# City of Alexandria, Virginia

## MEMORANDUM

**SUBJECT:** CONCEPT REVIEW OF 615, 615A AND 621 KING STREET  
BAR CASE # 2022-00078

**Figure 1: Portion of proposed addition visible from North Washington Street**

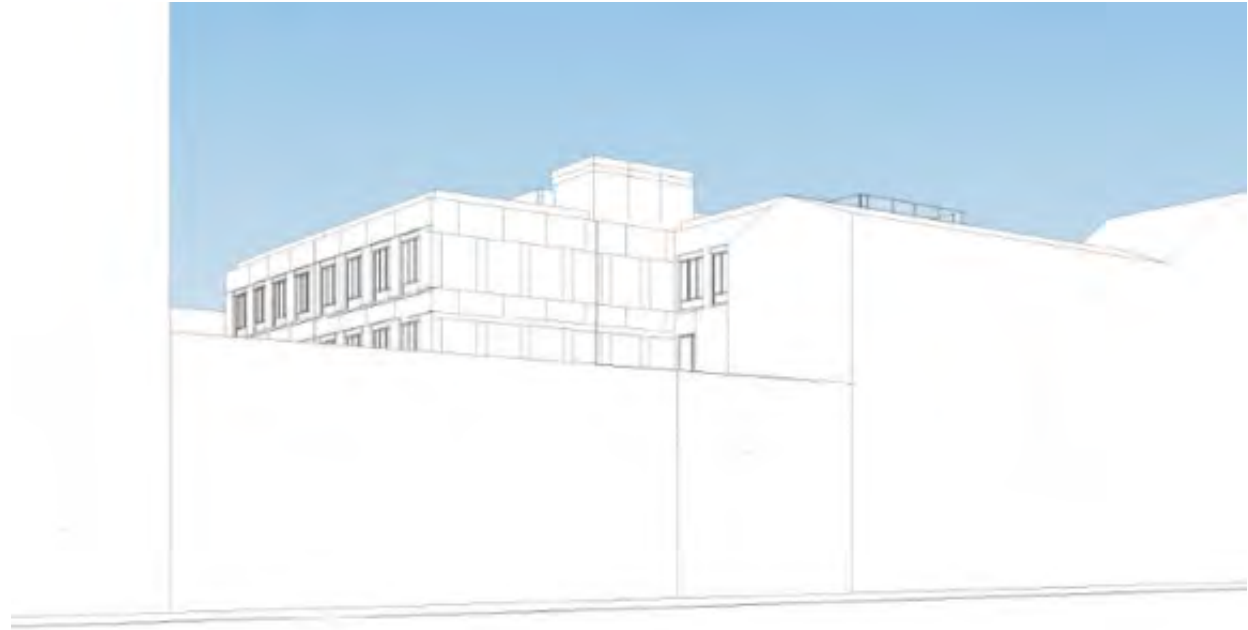
The project site consists of two properties on the north side of the 600 block of King Street, both of which are completely within the Old and Historic Alexandria District. The south elevations of both buildings are prominent portions of the King Street blockface. Directly behind the project site sits Ross Alley, a public right of way, which provides for visibility of the north elevation of both properties. As demonstrated in the submitted documents, a portion of the north and west elevations will be visible from Washington Street (Figure 1).
